То	Marchell Adams-David, City Manager
Thru	Patrick O. Young, AICP, Director
From	Ira Mabel, AICP, Senior Planner
Department	Planning and Development
Date	June 7, 2021
Subject	City Council agenda item for June 15, 2021 – Z-22-20 East End Market PD

Z-22-20 East End Market PD, approximately 11.16 acres located at <u>the northeastern</u> corner of the intersection of Whitaker Mill Road and Wake Forest Road.

RALEIGH PLANNING COMMISSION CERTIFIED RECOMMENDATION

Project number: L19028 Sheet #:
Issued Date: 06.17.2020
Drawn by: ---- C4.01
Approved by: ----

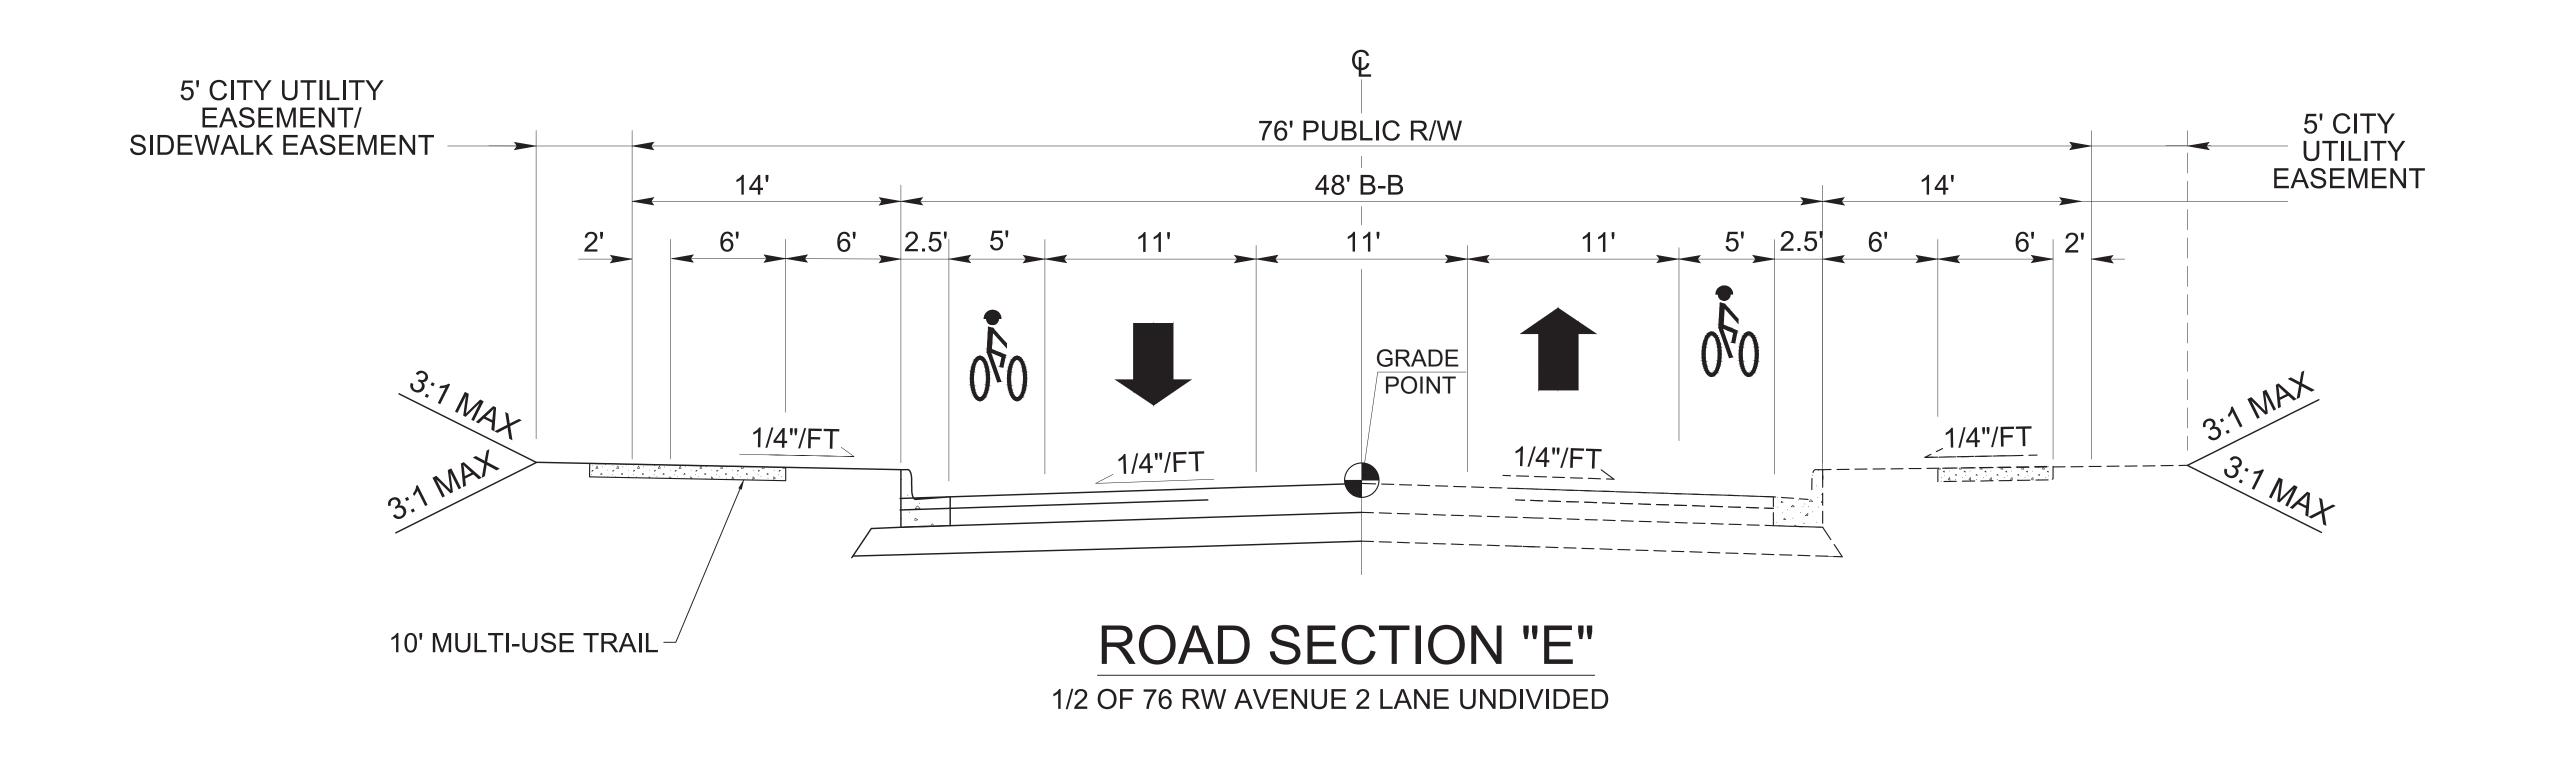
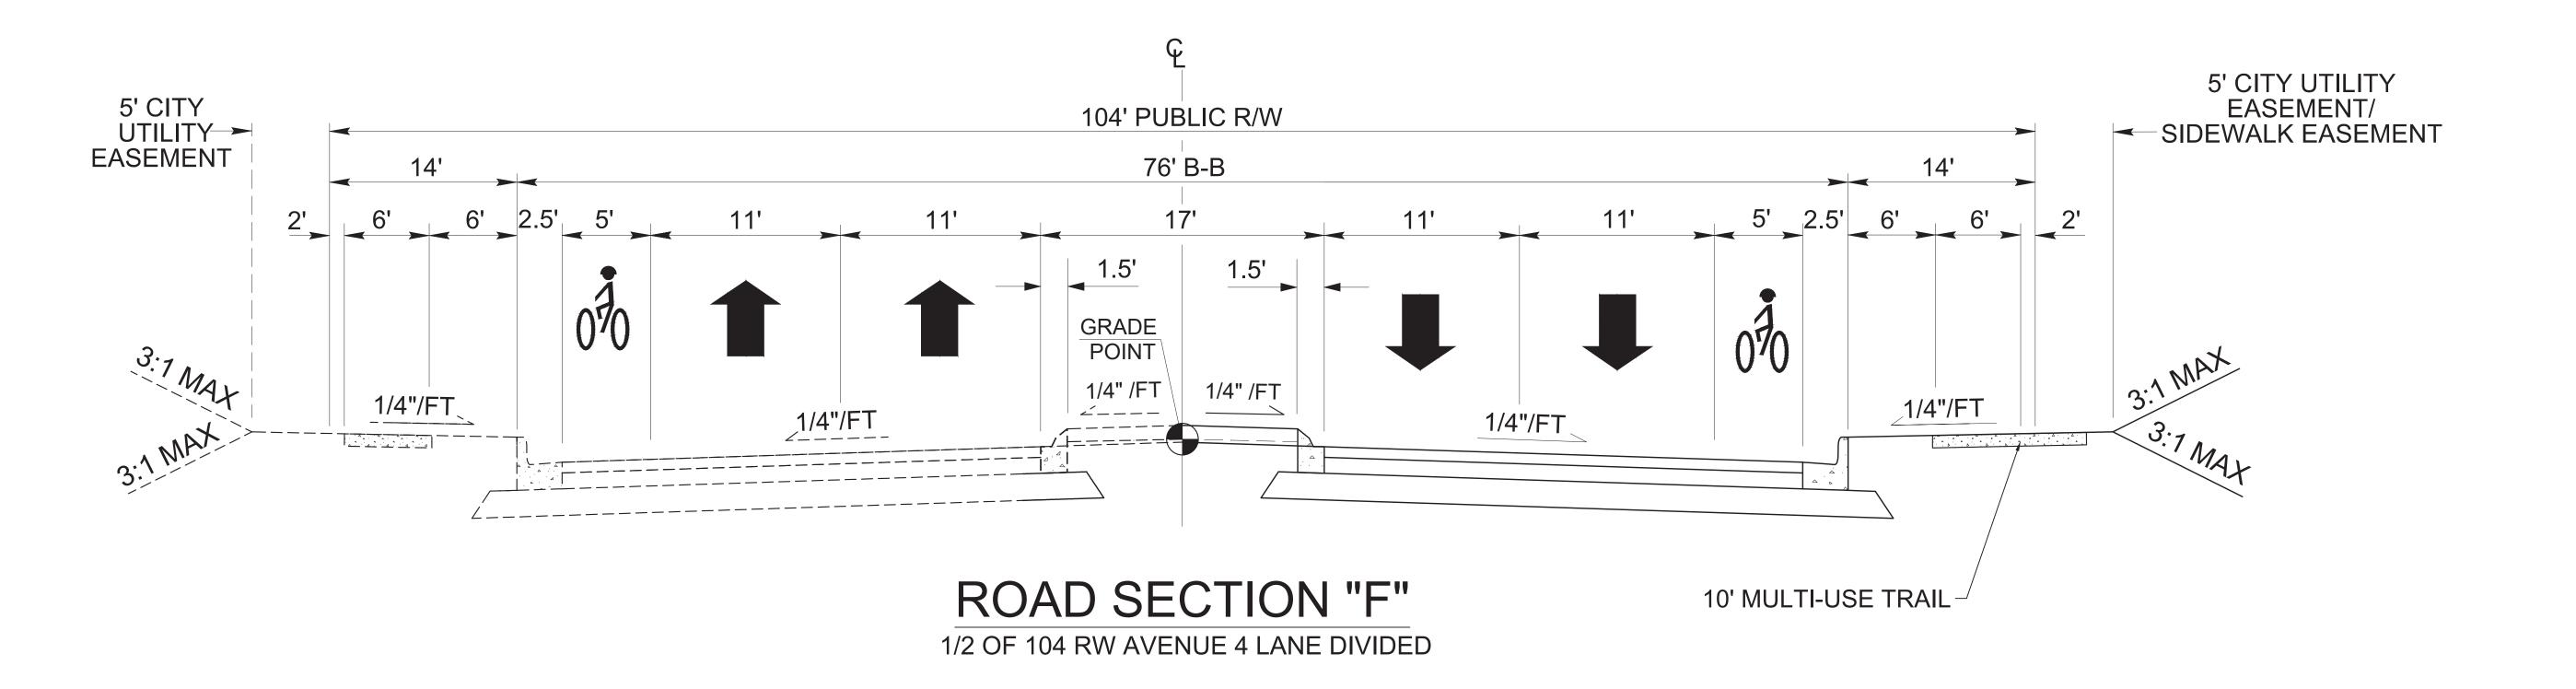
Internal public street are proposed in the Master Plan. These streets have custom cross sections shown on plan sheet C4.01. Cross sections meet appropriate dimensional standards for the context, though some sections of sidewalk are placed outside of the public right-of-way. Specific construction details are included in "Road Section 'D'" with a note that encroachments must be reviewed and approved during site plan review. Planning Commission and City Council should be aware that the specific design treatment of this cross section may not meet City standards or policy. Please refer to Transportation Development Engineering comments for more information on this issue.

- Indicate full vehicular cross access points to 2000 Wake Forest Road.
- Remove the bollards from the street cross sections.
